ADDENDUM NO. 1R

Drawings A100 & A102 dated 08/08/2017
Specifications: 09 65 16 Resilient Flooring

PROJECT:
STONEWALL RCMP DETACHMENT
STONEWALL, MB

1 GROUND FLOOR PLAN
A102 A102 1:50

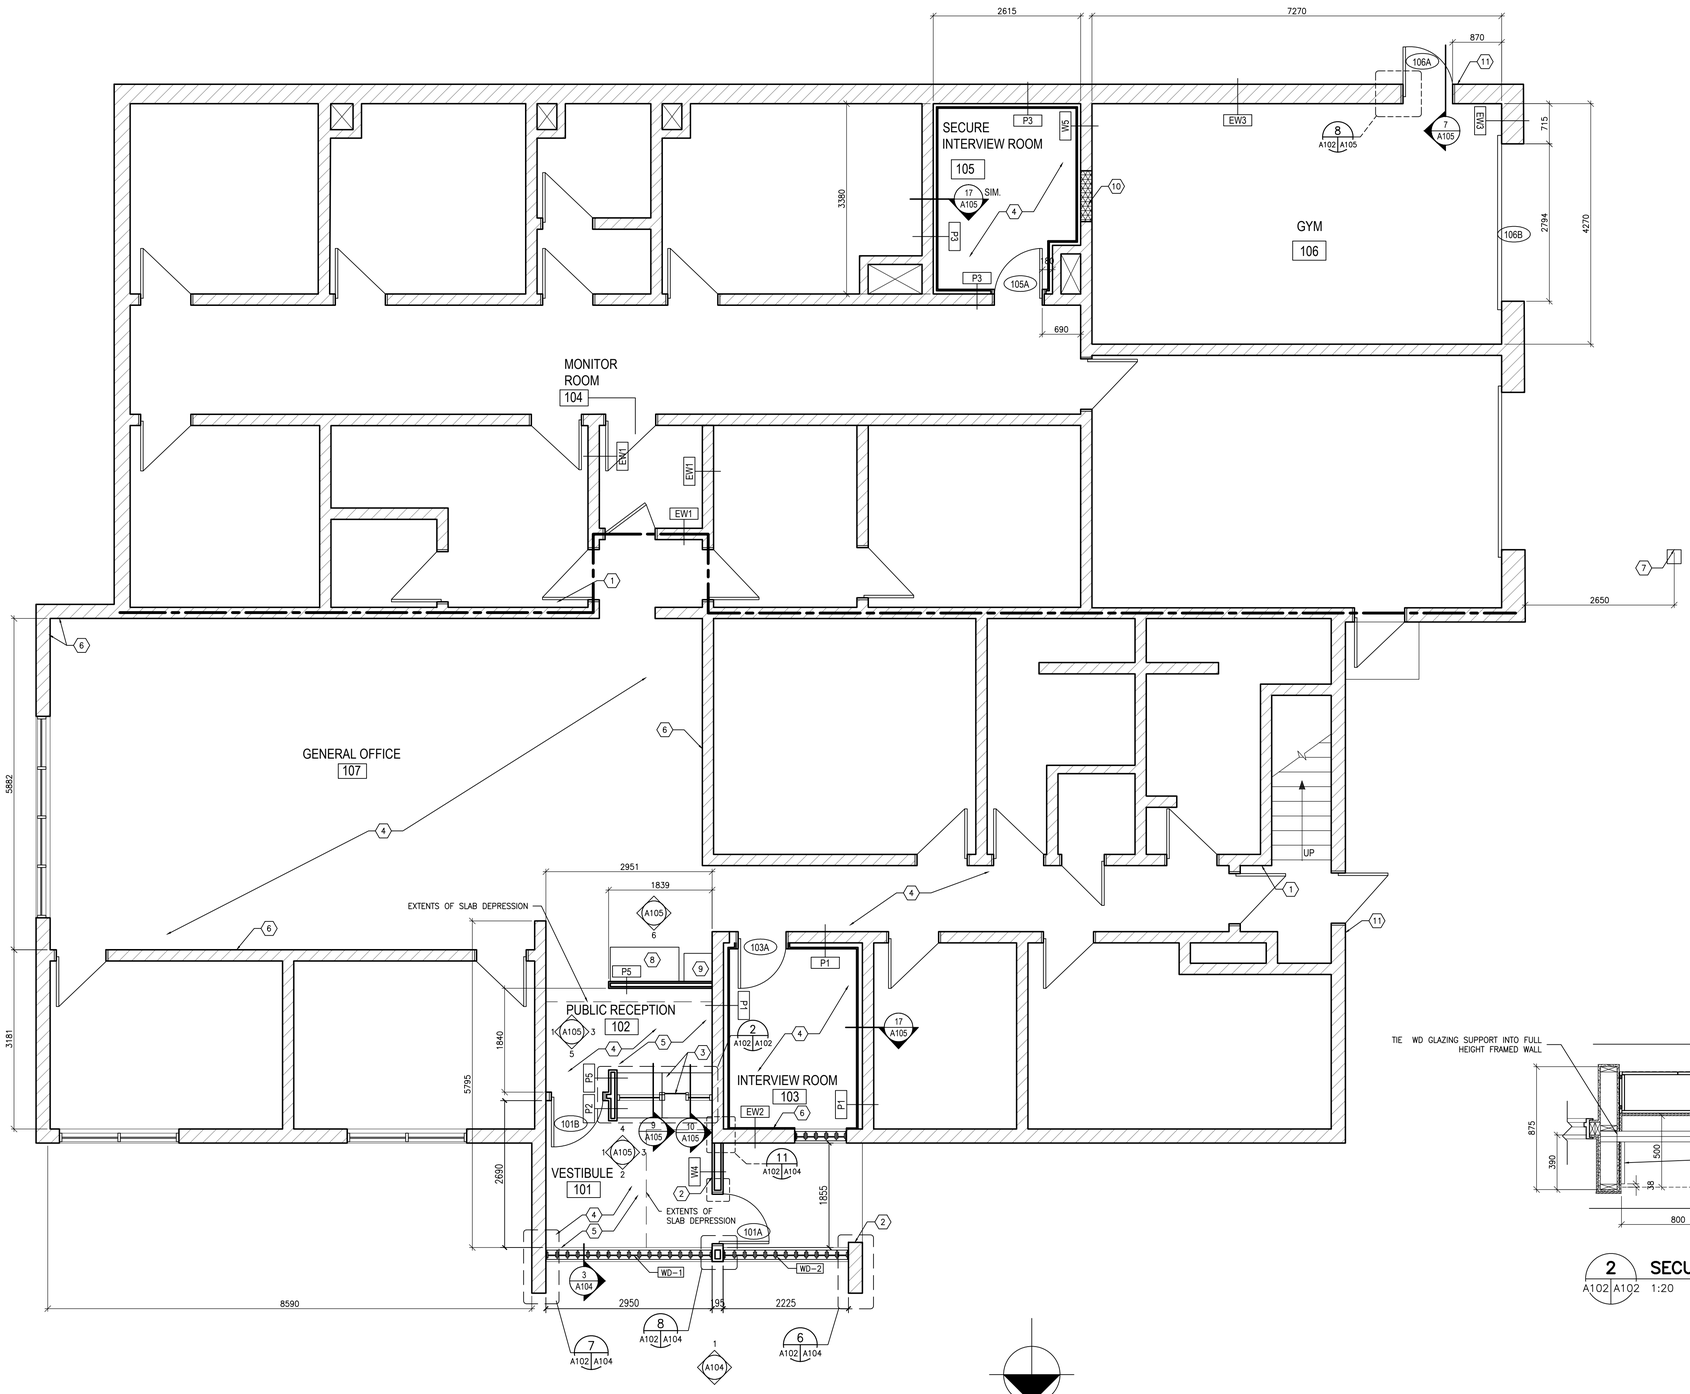
Reference: Drawing A102

a) Construction Keynote #4 revised to read: 4. Provide flooring and wall base within flooring upgrade extent.

1. PROVIDE ELECTRO MECHANICAL HOLD OPEN DEVICE ON PROVOST DOOR.
2. PUSH BUTTON DOOR OPENER.
3. SECURITY BARRIER, COUNTER & CABINETS. C/W REINSTALLED BIRCH SIDING.
4. PROVIDE FLOORING AND WALL BASE WITHIN FLOORING UPGRADE EXTENTS.
5. CONCRETE INFILL @ EXISTING SLAB DEPRESSION.
6. PROVIDE 16 GB LAMINATED OVER EXISTING WALL C/W NEW DOOR AND WINDOW TRIM. TRIM NEW GB TO EXISTING WINDOWS & DOORS W/ TEAR AWAY BEAD.
7. SWIPE CARD ACCESS FOR O.H. DOOR ON PEDESTAL.
8. PHOTOCOPIER, NOT IN CONTRACT.
9. STORAGE CUBBIES.
10. INFILL DOORWAY BETWEEN RM. 105 & 106 WITH CMU TO MATCH EXISTING WALL. TIE IN WALL FINISH ON RM. 106 SIDE TO EXISTING FINISH.
11. SWIPE CARD ACCESS.
